Project: Davis Sr. HS, All Student Center-19-16-032

DESCRIPTION OF CHANGE: CCD #005: Revised Electrical Site Plan

PROJECT
Change Order # 4

Drawing Title:
ELECTRICAL SITE PLAN

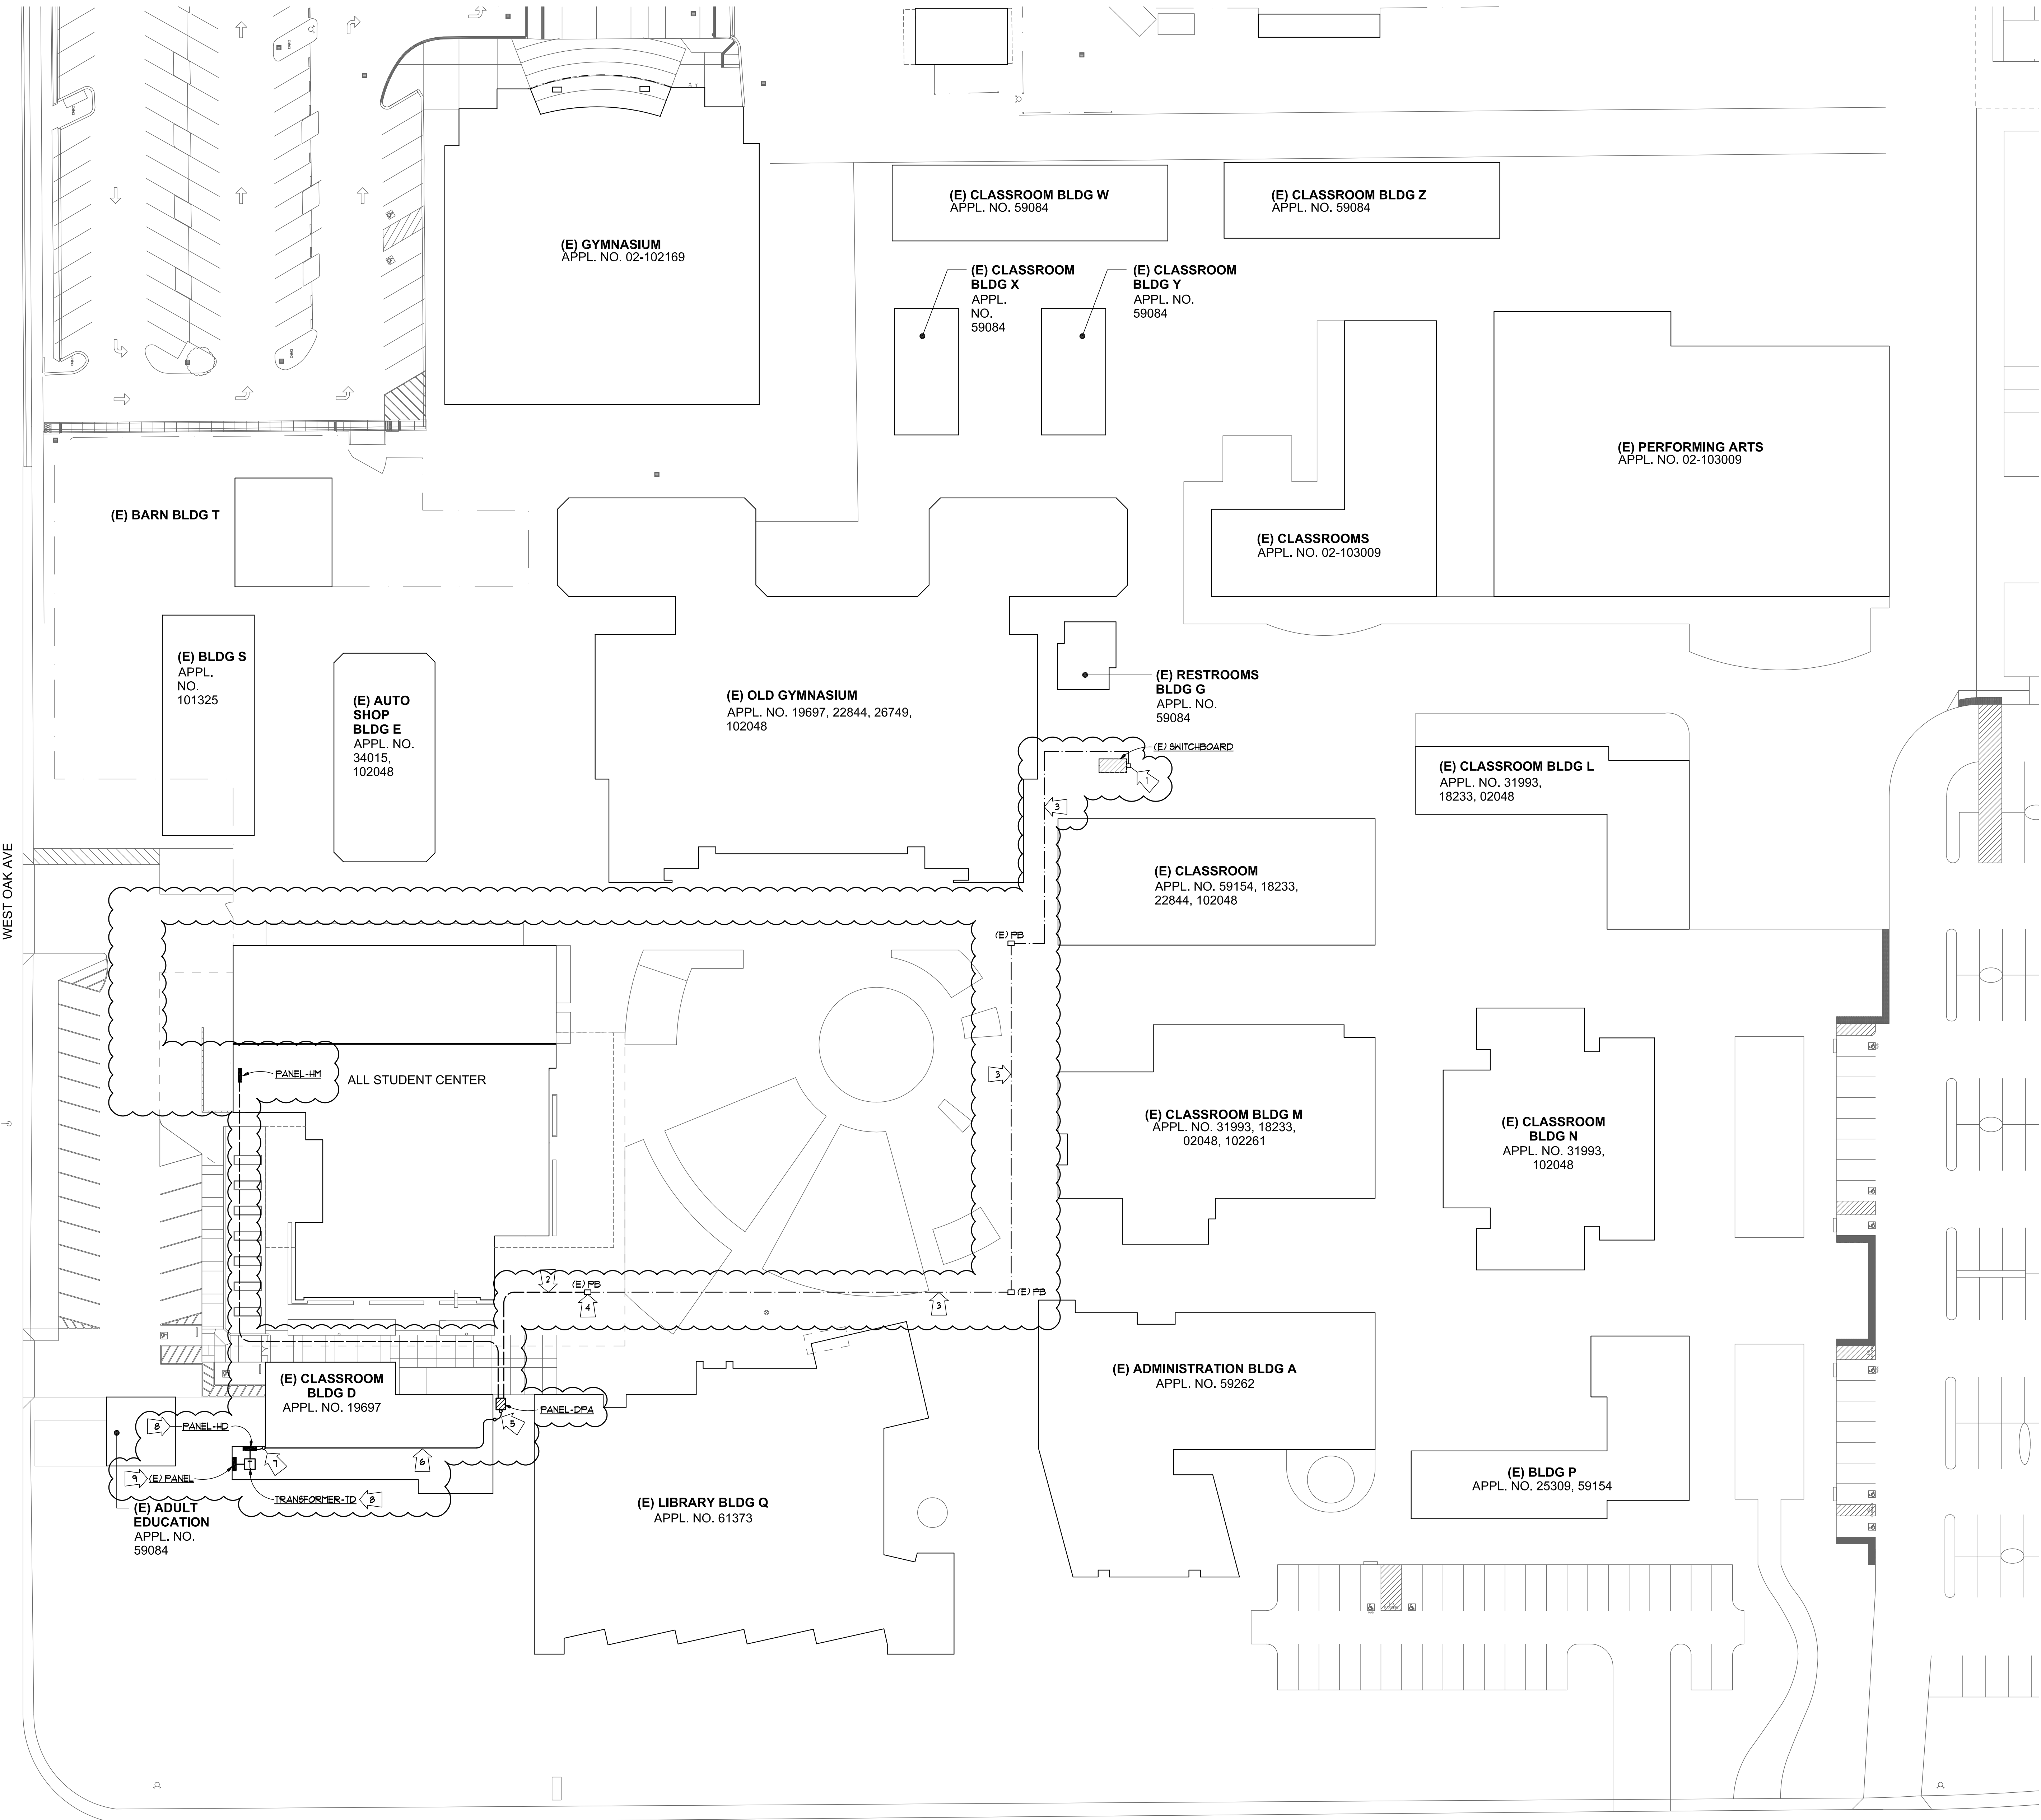
Added costs to revise the electrical underground to incorporate the additional power requirements at the robotics building per CCD #005.

No.	Description	Date
CCD-005	Electrical Service Revisions	12/01/16

- CONSTRUCTION NOTES:**
1. "LB" INTO (E) SWITCHBOARD SEAL PENETRATIONS WATER-TIGHT.
 2. SAW CUT CONCRETE AS REQUIRED. PATCH TO MATCH EXISTING.
 3. (E) 3-4" CONDUITS. PULL-IN WIRES. SEE ONE LINE DIAGRAM.
 4. EXTEND 1-4" CONDUITS TO PANEL-DPA. CAP 4-4" CONDUITS FOR SPARE.
 5. EXTEND CONDUIT FROM SIDE OF ENCLOSURE. RISE UP TO ROOF.
 6. ROUTE CONDUIT ON ROOF.
 7. DOWN TO MECHANICAL ROOF BELOW. SEAL ROOF PENETRATION WATER-TIGHT.
 8. VERIFY EXACT LOCATION ON JOB SITE PRIOR TO ROUGH-IN.
 9. DISCONNECT & ABANDON (E) FEEDER. RECONNECT AS REQUIRED.
